**DEFECT INFORMATION REPORT FOR DAIMLERCHRYSLER RECALL # B23**

# **Safety Recall No. B23**

## **Fuel Pump Module Secondary Seal**

2001-2002 (PT) Chrysler PT Cruiser

Figure 2

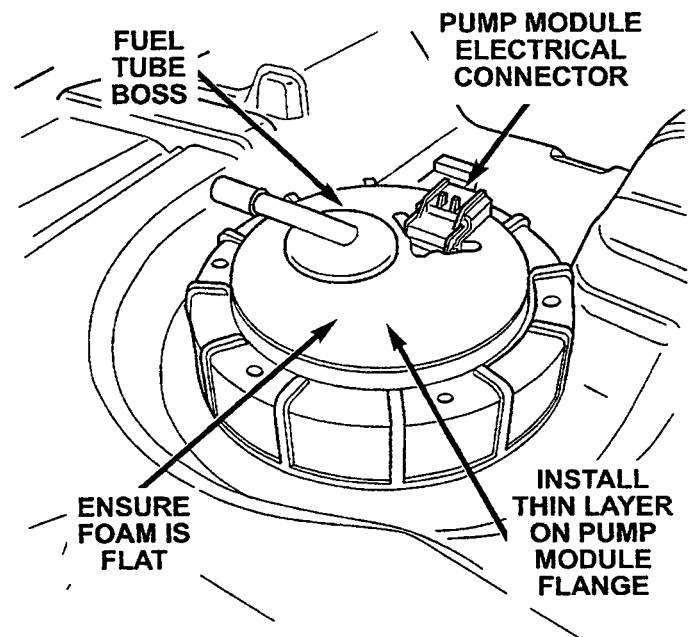
7. Place the thin foam layer directly on top of the fuel pump module flange (Figure 2). Make sure that the appropriate sized cut-out is placed around the pump module electrical connector and fuel tube boss. Ensure that the foam lies flat on the pump module flange.

Figure 3

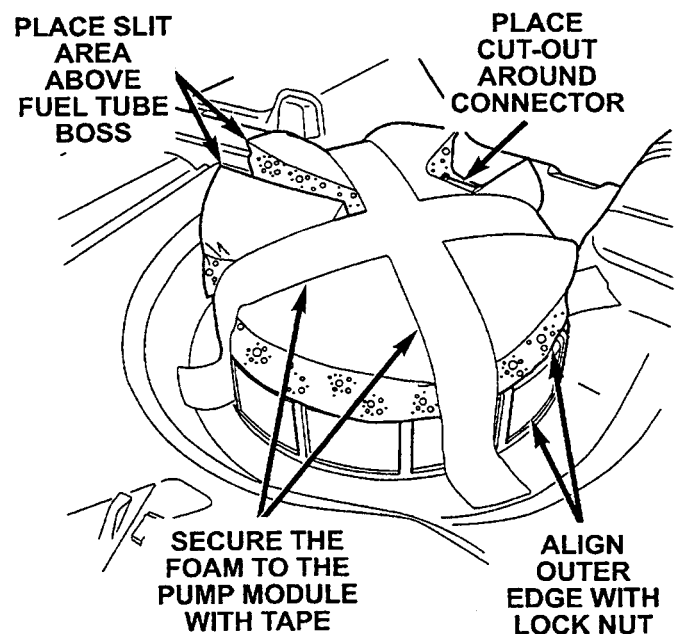
9. Install the thick foam layer with cut-outs on top of the pump module and thin foam layer (Figure 3). Make sure that the cut-out is placed around the pump module electrical connector and that the slit area is above the fuel tube boss.
10. Align the outer edge of the foam with the pump module lock nut and secure it to the fuel pump module with electrical tape as shown in Figure 3.

Figure 4

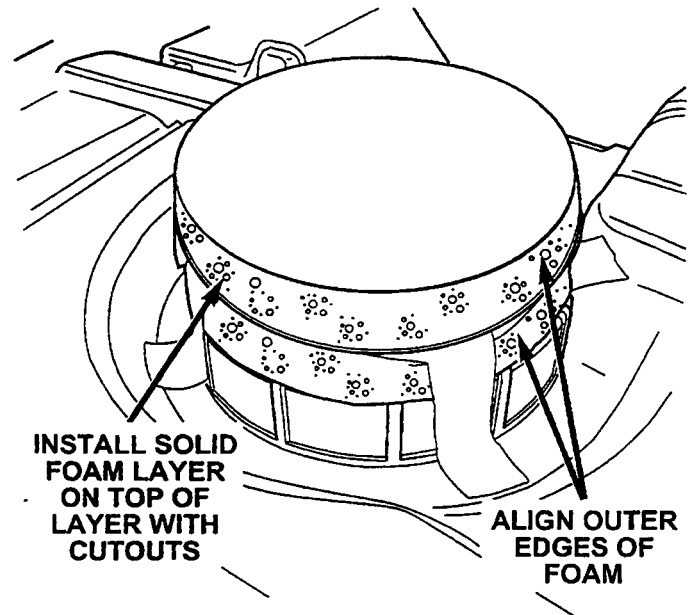
11. Remove the protective paper from the adhesive on one of the solid thick foam layers (no cut-outs or slits). With the adhesive side facing downward, install the foam on top of the pump module and thick foam layer with cut-outs (Figure 4).

Figure 5

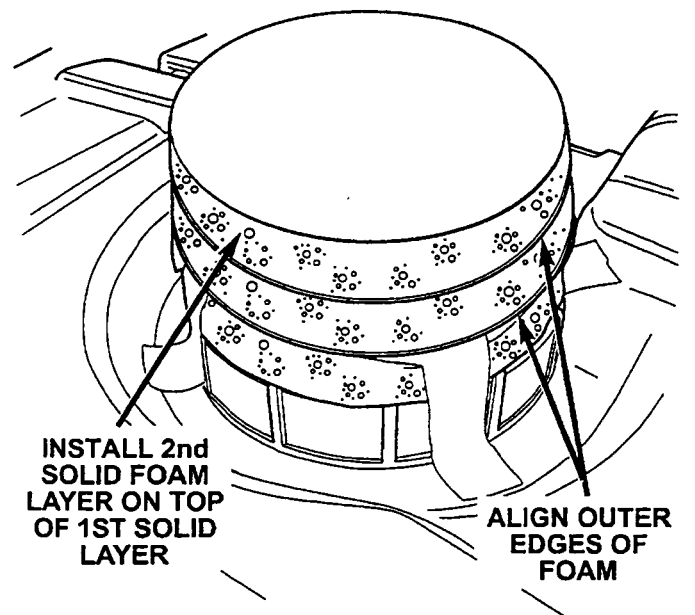
12. Remove the protective paper from the adhesive on the remaining solid thick foam layer. With the adhesive side facing downward, install the foam on top of the pump module and first solid thick foam layer (Figure 5).
13. Carefully raise the fuel tank into position. Make sure that the foam layers remain in place on top of the fuel pump module.
